SERVICE INSTRUCTION

Information on regulator B modifications for ROTAX® Engine Type 912 i (Series)

ATA System: 76-10-00 Fuse box

Fig. 1
Fuse box view onto regulator B

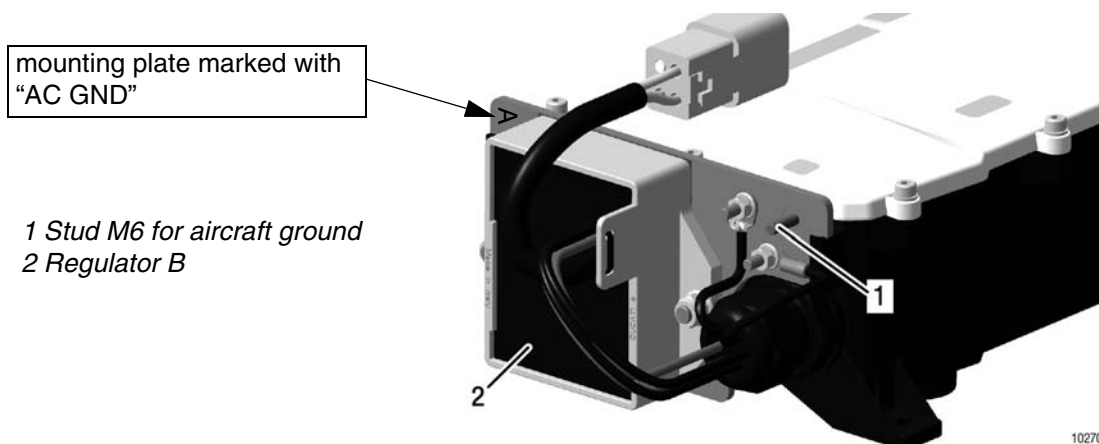
When retrofitting the new regulator B (part no. 864395) to an older engine, the connection to the AC GND plate must have its ground connectors replaced with smaller M4 ring terminal.

See Fig. 1.

For the modification from M6 to M4 ring terminals the following assembly steps do apply:

Step	Procedure
1	Cut off the M6 ring tongue with a standard wire cutter.
2	Strip off 6 mm of the wire's insulation with a standard wire stripper.
3	Crimp the M4 ring terminals with the crimping tool.

Fig. 2
Crimping tool and PIDG ring terminal

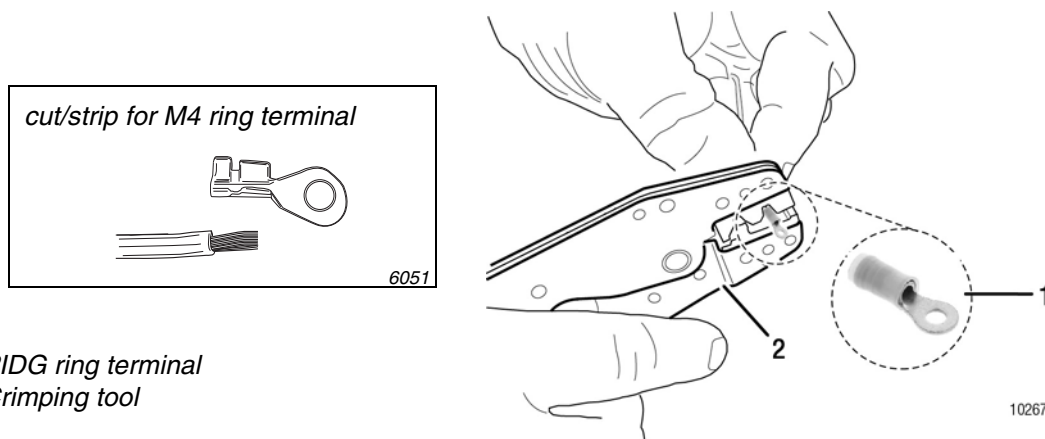
NOTE: Use of a proper “double crimp” tool suitable for “PIDG ring terminals” type crimp connectors (like e.g. KNIPEX MultiCrimp no. 97-39-06) might be necessary for secure connections of M6 ring terminals.
